File Note

Project Title	HIF Banwell Bypass and Highways Improvements Project
Document Title	Wider Network Mitigation - Additional Speed Survey Data
Document Reference	BNWLBP-ARP-HGN-XXXX-TN-CH-000001
Prepared by	Rob Henley
Status	S8 FOR PLANNING APPLICATION
Revision Date	P02 13/12/22

1.1.4 This Technical Note summarises the results of the additional speed surveys undertaken and sets out the amended extents to the speed limit proposals as shown on updated Wider Network Mitigation – General Arrangement Drawings.

Figure 2 Updated wider mitigation proposals (December 2022 – current)

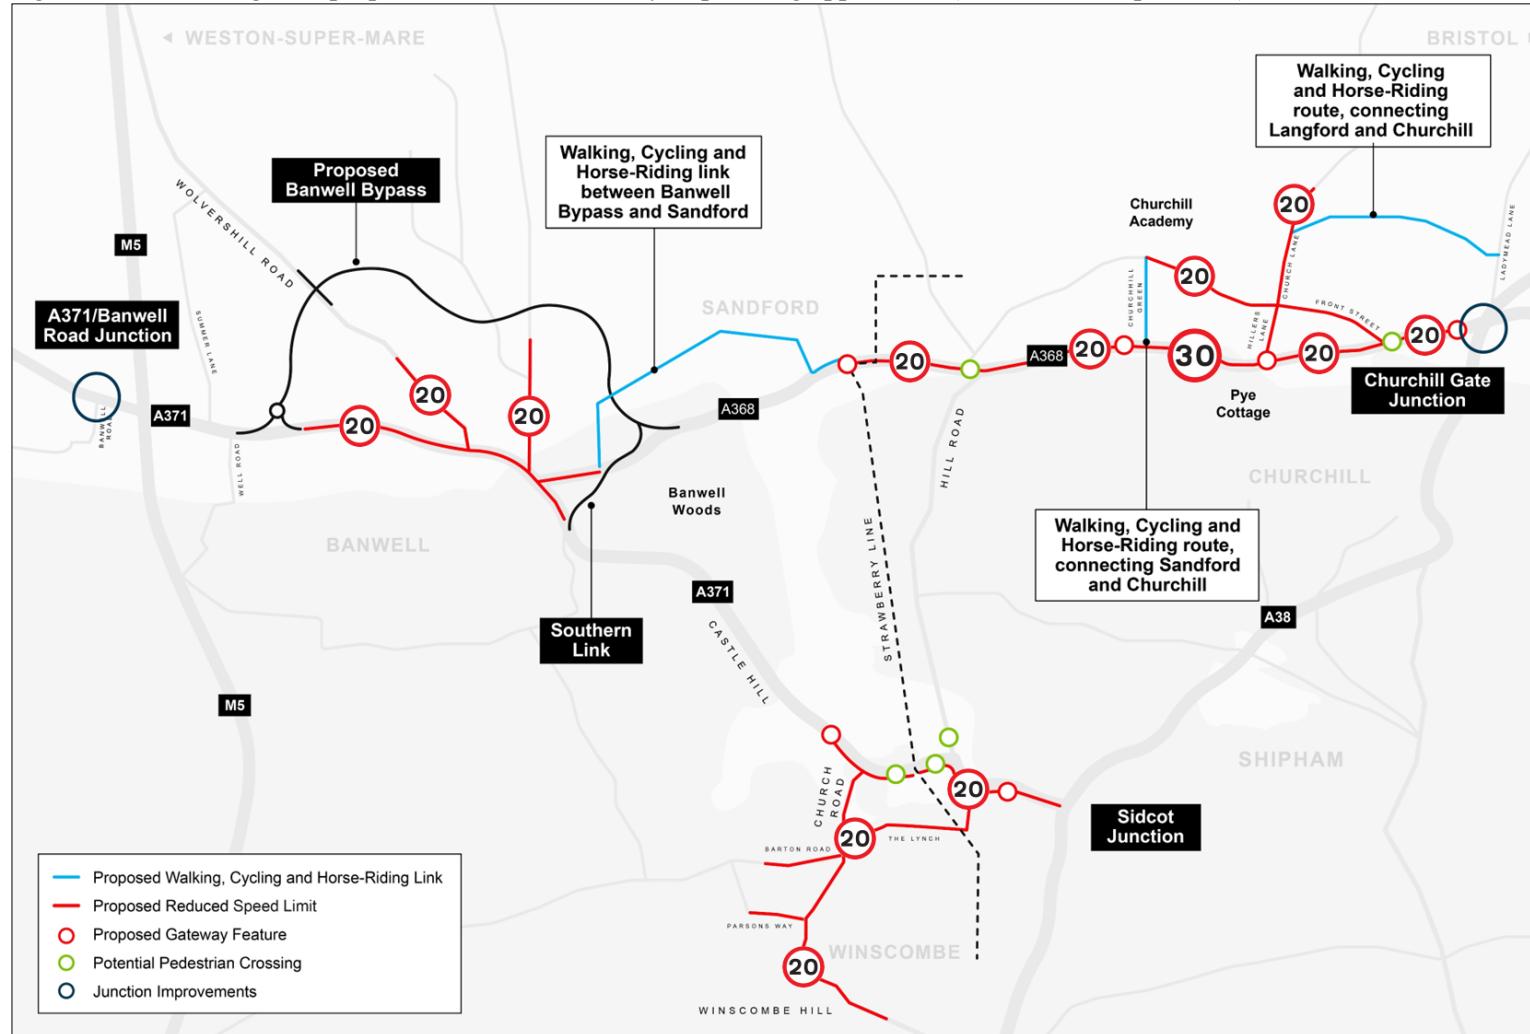
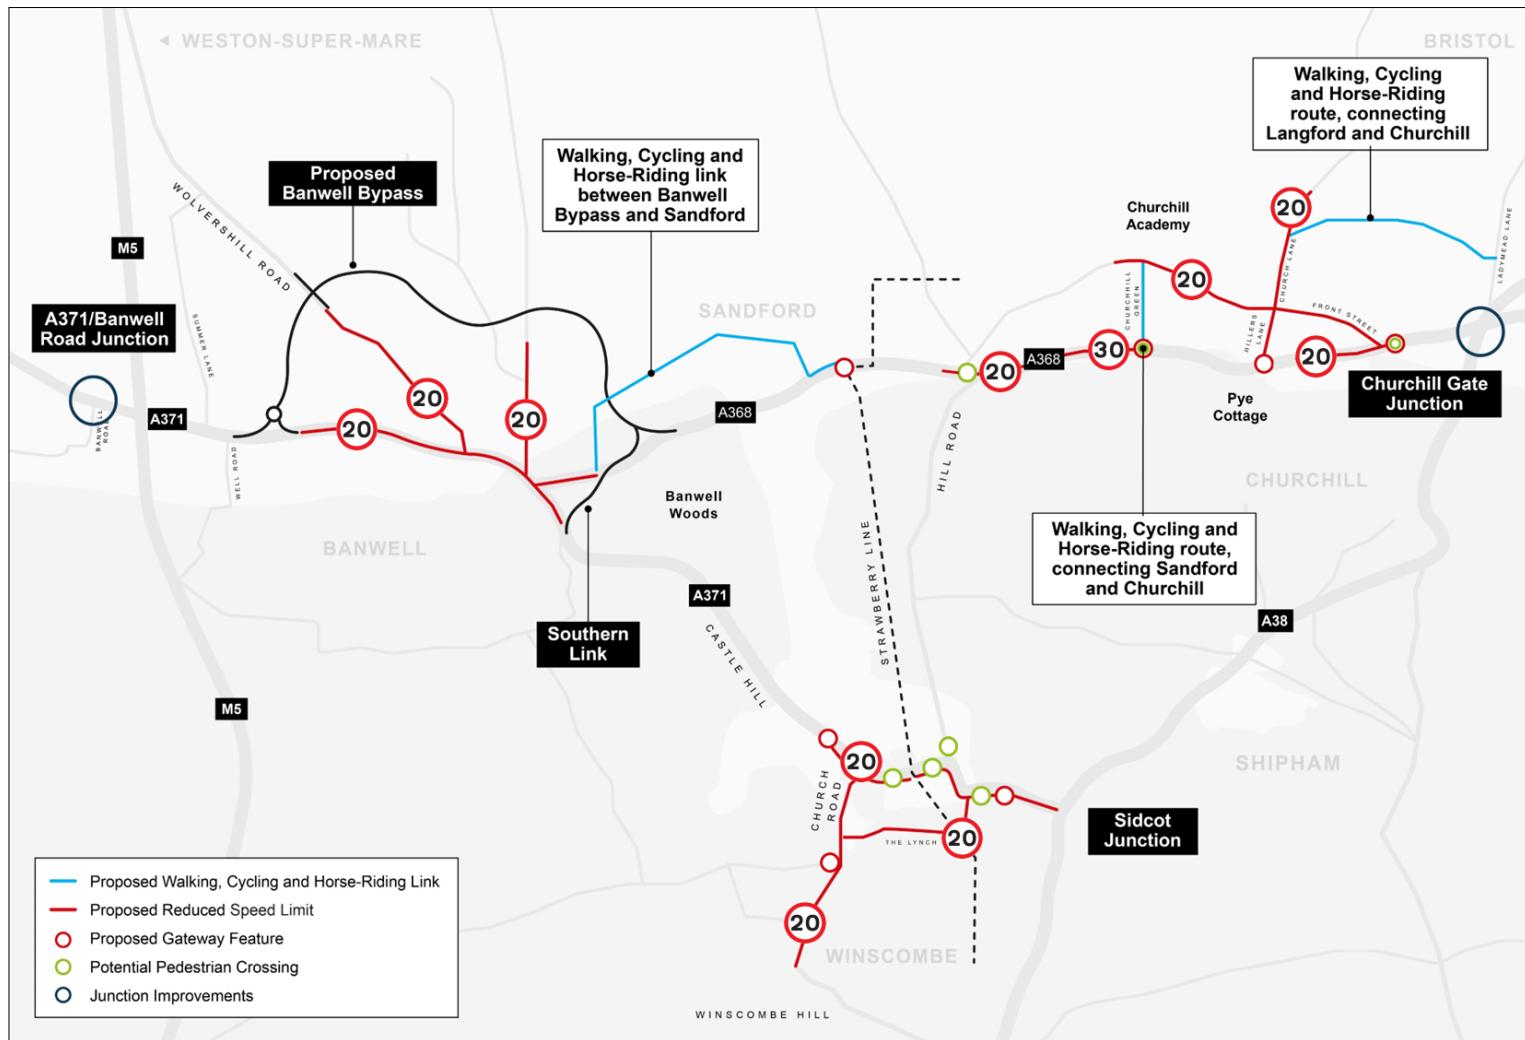
1.1.5 A summary of the wider mitigation measures as submitted for planning initially and the updated proposals now put forward are shown in Figure 1 and Figure 2 respectively.

Figure 4 Sandford speed survey results (west)

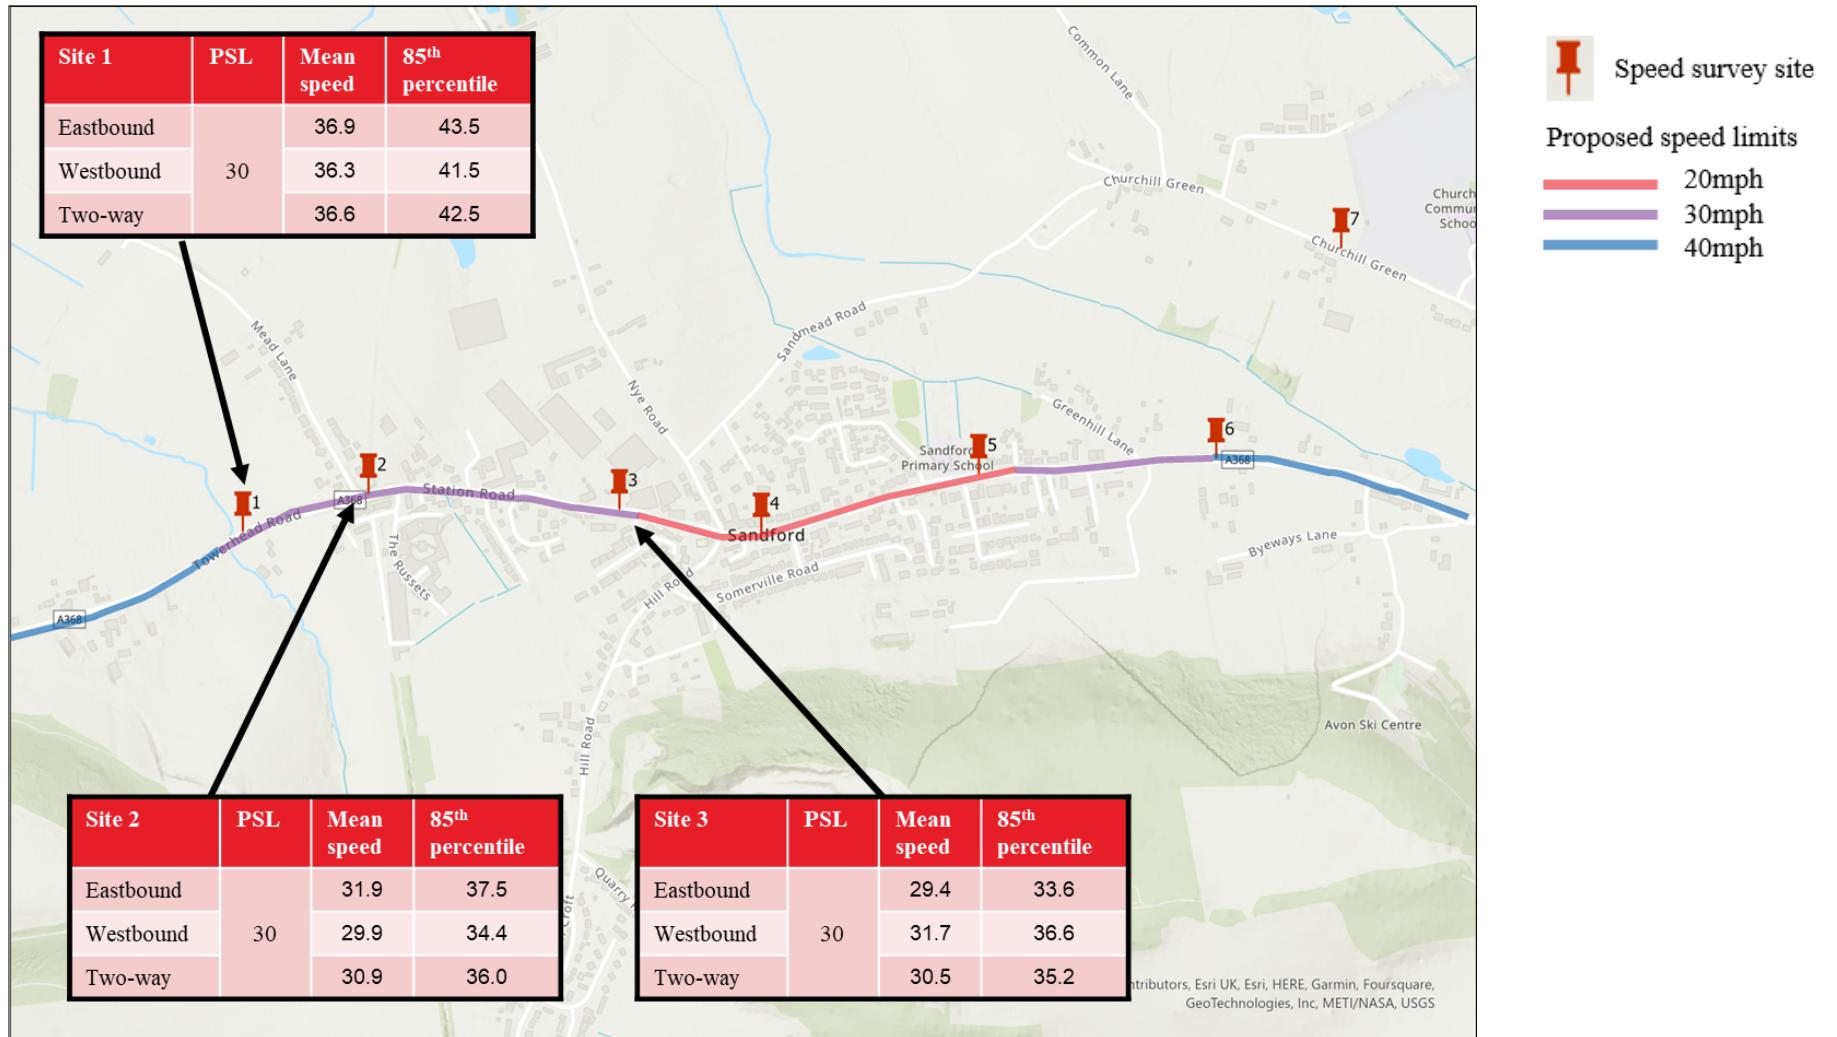
3.1.4 Traffic speed surveys along the A368 (Towerhead Road and Station Road) to the west of Sandford (survey sites 1, 2 and 3) indicate that mean vehicle speeds in both directions exceed the current speed limit of 30mph to varying degrees. This is most acute at survey site 1 where the mean speeds in both directions exceeds the speed limit by 23%. The following infrastructure changes are proposed to increase compliance with the current speed limit as well as increasing safety for all users:

1. Gateway feature when approaching the village from the west;
2. Narrowing of carriageway on Towerhead Road by creating the new shared use path towards Banwell;
3. Enhancement of existing Toucan crossing with raised crossing and increased signal priority for pedestrians and cyclists;
4. Continuous cross-over of shared use footway/cycleway on Mead Lane to provide priority to pedestrians and cyclists;

5. Narrowing of carriageway on Station Road with raised bus boarders and widened footways;
6. New raised puffin crossing west of Hill Road; and
7. Enhancement of existing uncontrolled pedestrian crossing of Nye Road at its junction with Station Road.

Figure 5 Sandford speed survey results (east)

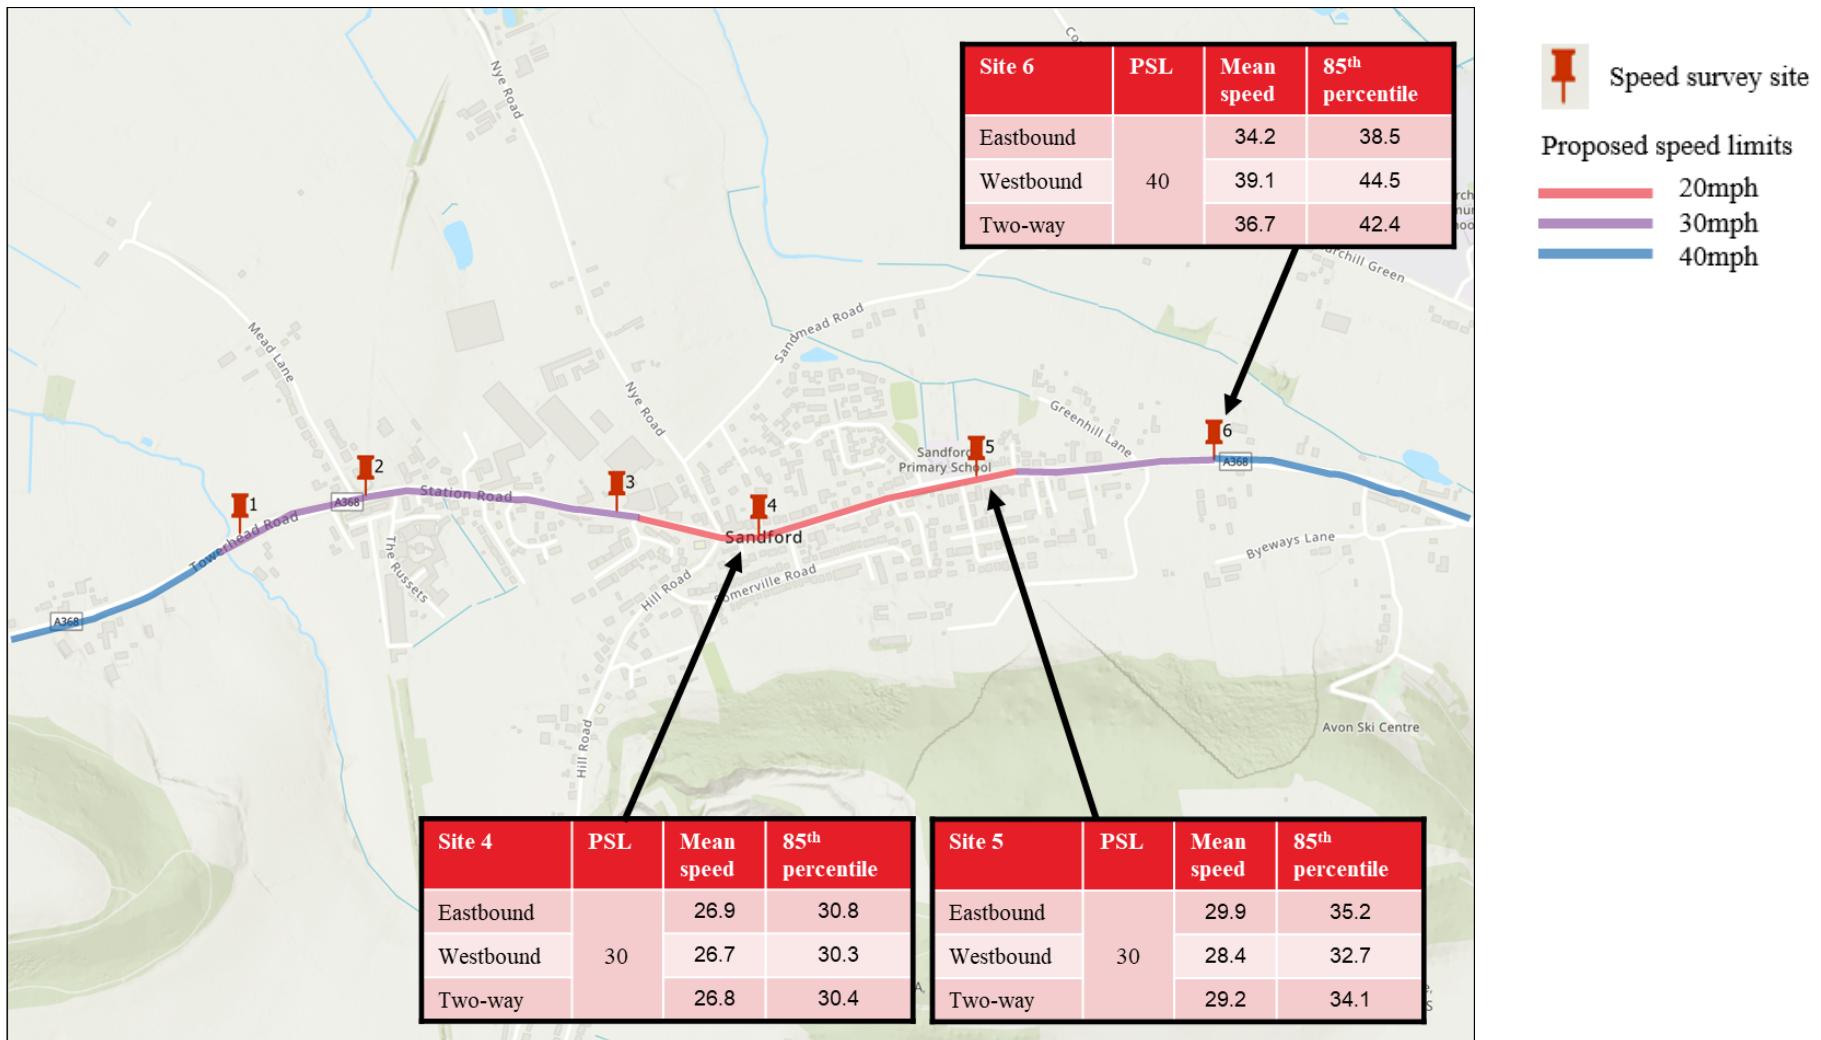
3.1.6 The speeds surveys along the A368 Greenhill Road) east of Hill Road (survey sites 4 and 5) indicate that mean vehicle speeds are lower than the current speed limit of 30 mph. Since most vehicles currently drive slower than the speed limit on this section of the A368 the proposal for a 20mph speed limit would require fewer infrastructural intervention as drivers already moderate their speed. Plans for a 20mph speed limit along this section of Greenhill Road are proposed with the following accompanying infrastructure:

1. Hatched road markings to reduce effective carriageway width and encourage slower vehicle speeds;
2. Modification of existing pedestrian crossings outside the primary school and village hall, including raised crossings, carriageway narrowing and increased signal priority for pedestrians;
3. Gateway feature when approaching the village from the east; and
4. Removal of bus lay-bys, to increase priority to public transport services.

3.1.7 The existing 30mph to 40mph transition to the east of the village is proposed to be extended further east (survey site 6) to reduce speeds where the proposed upgraded PROW emerges onto the A368. A refuge island with narrowed lane widths is proposed in this location to reduce vehicle speeds and facilitate crossing movements.

Figure 6 Speed survey results in Churchill

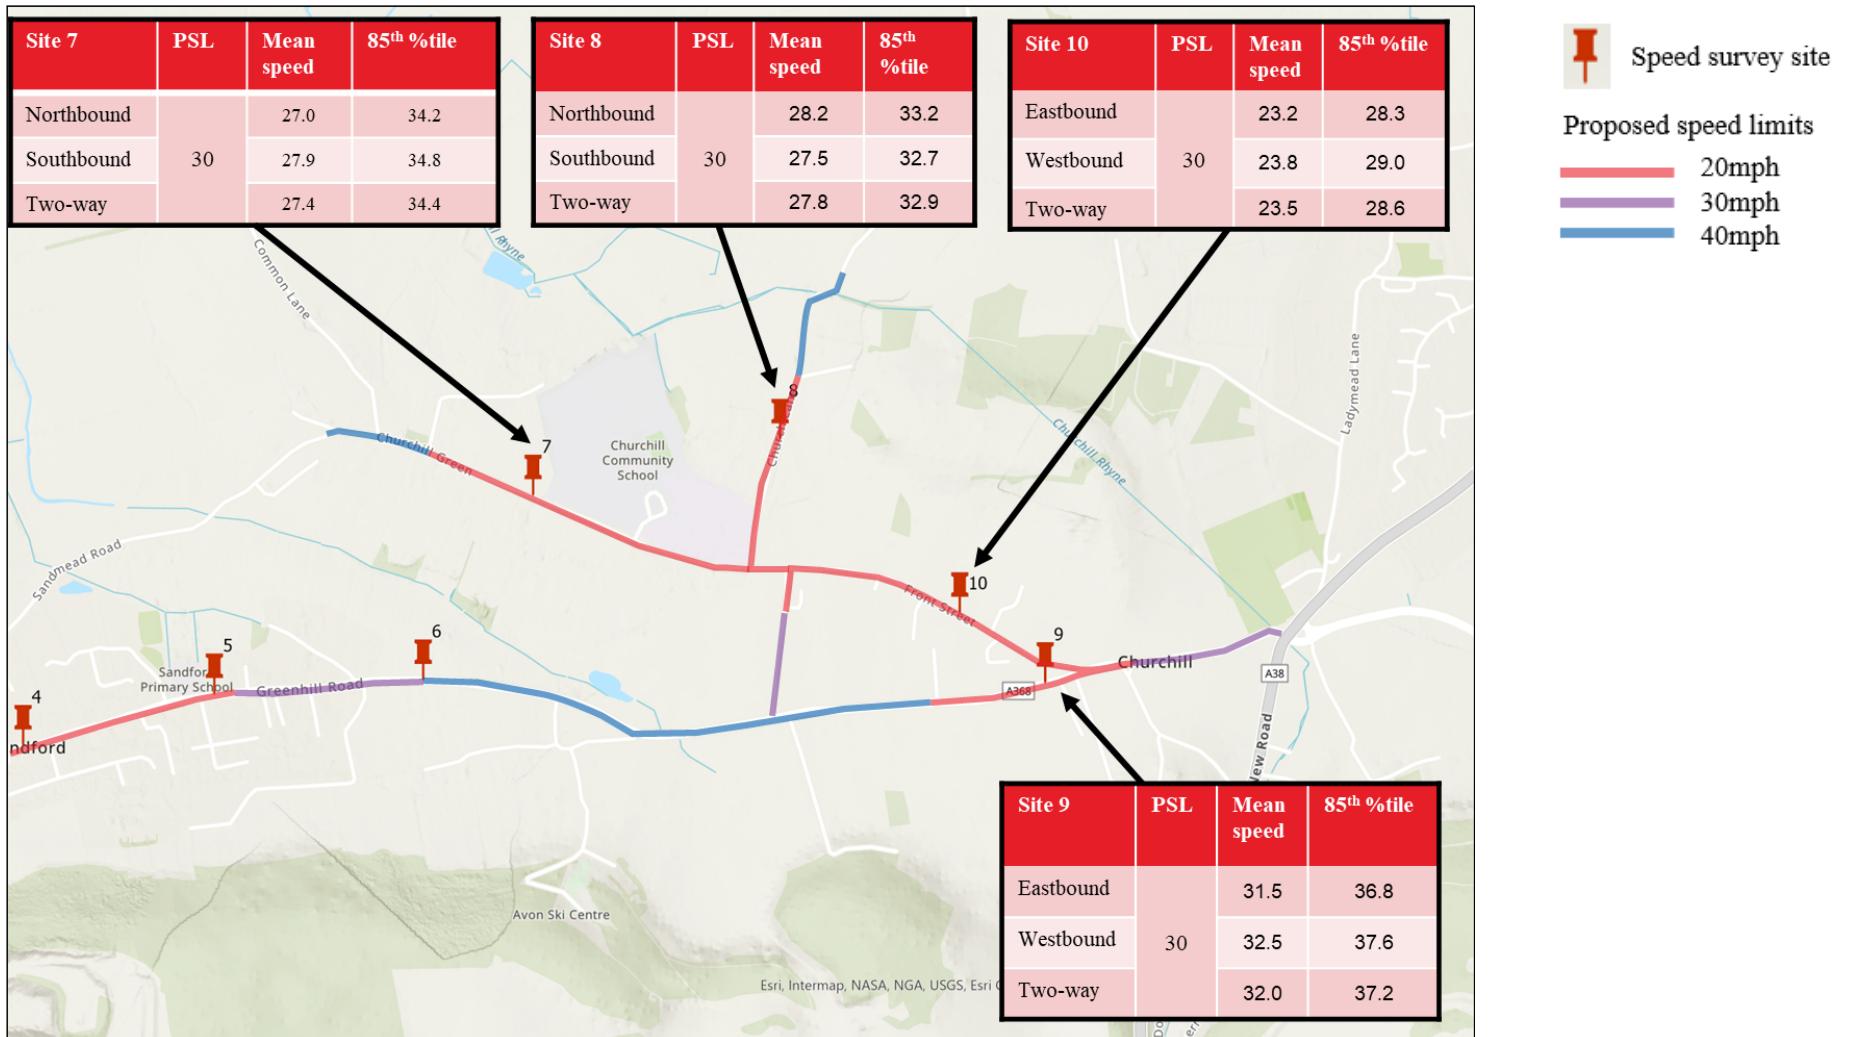
4.1.1 This section details the additional speed survey results and revised speed limit proposals in Churchill. The survey results have informed and provided justification for the proposed speed limit changes. The following roads in Churchill are proposed for speed limit reductions to 20mph:

1. Hillier's Lane;
2. Dinghurst Road (between The Drive and Skinners Lane);
3. Front Street; and
4. Church Lane.

4.1.2 40mph buffers are also proposed where the speed limits transition from national speed limit to 20mph on Churchill Green and Church Lane. East of the Skinners Lane, the existing 30mph speed limit to Churchill Gate junction is proposed to be retained.

4.1.4 The traffic speed survey along Dinghurst Road (survey site 9) indicates that mean vehicle speeds in both directions slightly exceed the current speed limit of 30mph. These survey results are consistent with plans to provide enhanced infrastructure along this section to encourage compliance with the proposed lower speed limit of 20mph. The proposed traffic calming measures along at this road section include:

1. Gateway treatments on Dinghurst Road, east of the junction with Hillier's Lane and by Skinners Lane; and
2. Raised Puffin crossing proposed outside the Beaches, including carriageway narrowing; and
3. Two raised table features between The Drive and Front Street.

4.1.6 The speed surveys along Front Street (survey site 10) indicate that mean vehicle speeds in both directions are lower than the current speed limit of 30mph and lower than 24mph in both directions. Compliance with the proposed 20mph reduced speed limit is therefore expected with a lighter-touch approach, based on traffic signs and lining only.

4.1.8 The speed surveys along Churchill Green (survey site 7) indicate that mean vehicle speeds in both directions are lower than the current speed limit of 30mph. The following infrastructure is proposed to support compliance with proposed 20mph speed limit:

1. Build-outs requiring vehicles to give way through narrowings; and
2. Carriageway narrowing by provision of ghost footway linking extents of existing footway with upgraded PRoW connection.

4.1.10 The traffic speed survey along Church Lane (survey site 8) indicates that mean vehicle speeds in both directions are lower than current speed limit of 30mph. The following infrastructure is proposed to support compliance with proposed 20mph speed limit:

1. Carriageway narrowing, through the construction of a new section of footway;
2. Build-outs requiring vehicles to give way through narrowings;
3. Cycle road markings at regular intervals to highlight presence of cyclists;

4. “SLOW” road markings; and
5. Raised table crossing for access to the upgraded PRoW connection towards Sandford, with carriageway narrowed to one lane at crossing, with vehicles required to give-way in one direction.
